Technical Note

Project: Ryebank Chorlton

Title: Stage 1 Road Safety Audit (Updated) – Designer's Response

LONGFORD ROAD, CHORLTON-CUM-HARDY DEVELOPMENT SECTION 38 AND 278 WORKS STAGE 1 ROAD SAFETY AUDIT

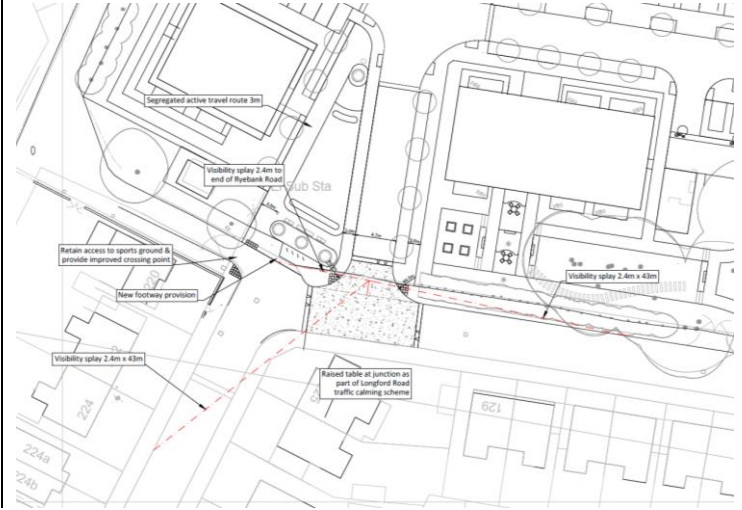
Problem	Recommendation	Response
1. Speed table not perpendicular to approaching traffic A junction table is proposed on Longford Road at the new access (near 225, Ryebank Road). Its design is such that drivers approaching from Ryebank Road will meet the entry ramp at an angle. This means that the vehicle will negotiate the ramp one wheel at a time, resulting in a bumpy, rocking motion, which may cause injury to the vehicle occupants. If the vehicle is a cycle or a powered two wheel vehicle, then it may result in a loss of control and the rider becoming unseated.	It is recommended that the design of the junction table is such that vehicles will approach the entry ramp perpendicularly.	As previous audit. Recommendation accepted, entry ramp to be amended, indicative amendment below subject to MCC Highways review of RSA and confirmation.  The drawing is a technical plan view of a road junction. It shows a road labeled 'Longford Road' with a proposed 'Speed table' at the junction. A 'Sub Sta' (substation) is located near the junction. A 'Segregated active travel route 3m' is shown. A 'New footway provision' is indicated. A 'Retain access to sports ground & provide improved crossing point' is noted. A 'Visibility splay 2.4m x 43m' is shown. A 'Raised table at junction as part of Longford Road traffic calming scheme' is indicated. The drawing also shows buildings and other road features.

4. Pedestrian visibility

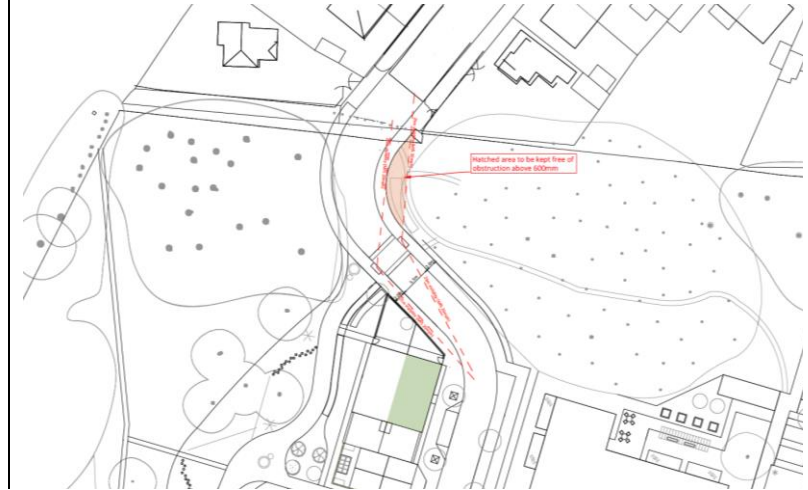
There is a pedestrian crossing facility proposed as above. It appears from the drawing that the pedestrian visibility splay on the eastern side looking north will cross an area of land which may be outside the public highway. This could result in obstructions to visibility being constructed/sited on that land which will reduce visibility. If pedestrians cannot see approaching vehicles and vice versa, then a pedestrian/vehicle collision may result.

It is recommended that pedestrian have sufficient visibility to cross safely.

Recommendation accepted – pedestrian visibility has been reviewed, requirements confirmed below:

Summary: **Speed table not perpendicular to approaching traffic**

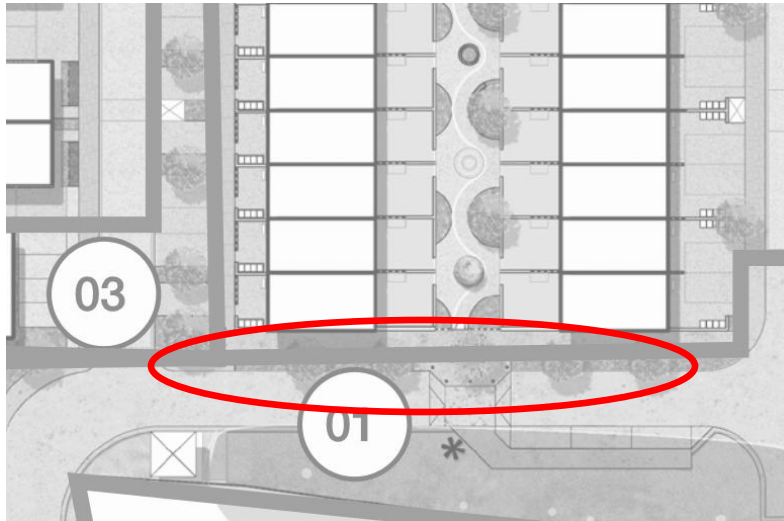
A junction table is proposed on Longford Road at the new access (near 225, Ryebank Road). Its design is such that drivers approaching from Ryebank Road will meet the entry ramp at an angle. This means that the vehicle will negotiate the ramp one wheel at a time, resulting in a bumpy, rocking motion, which may cause injury to the vehicle occupants. If the vehicle is a cycle or a powered two wheel vehicle, then it may result in a loss of control and the rider becoming unseated.

It is recommended that the design of the junction table is such that vehicles will approach the entry ramp perpendicularly.
